Denial of a Certificate of Appropriateness – 1024 W. Chew Street

**HDC-2022-00074**

**Address: 1024 W. Chew Street**

**Proposal: Install vent at Howard Street elevation; repoint brick**

Original proposal: Red line showing roughly where the vent would be located.  
(Applicant photo; staff added line)

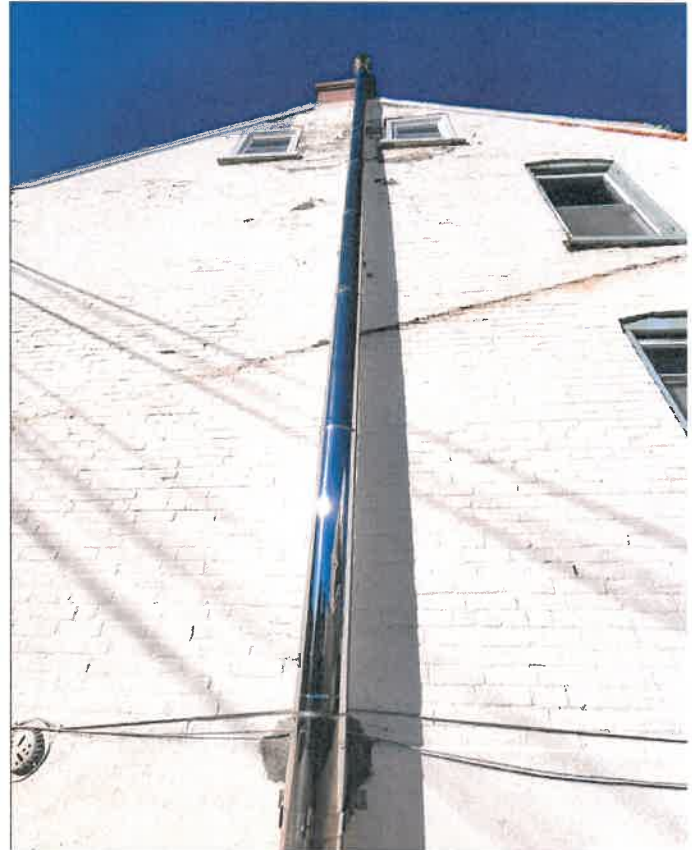
The proposed vent would be located on a highly visible contributing secondary façade and does not comply with the venting guidelines in Chapter 3.8 of the historic district guidelines, which recommend minimizing the visibility of vents and penetrations from the public right-of-way.

The applicant noted in the application that the existing chimney line was previously assessed and determined to be insufficient in size. With this condition, the proposed use of an exterior vent may be considered consistent with Guideline 3.8.9. An alternative vent design, similar to a direct vent (horizontal) type, would be less visually intrusive than a full height vent, provided that it complies with required codes. Painting the exterior vent to blend into the exterior brick wall would help the proposed work comply with Guideline 3.8.8.

Approval of the masonry pointing, provided an appropriate mortar is used, pursuant to Chapter 3, Section 3.3 Masonry, and denial of the installation of the exterior vent, pursuant to Chapter 3, Section 3.8 Mechanical & Utility Equipment.
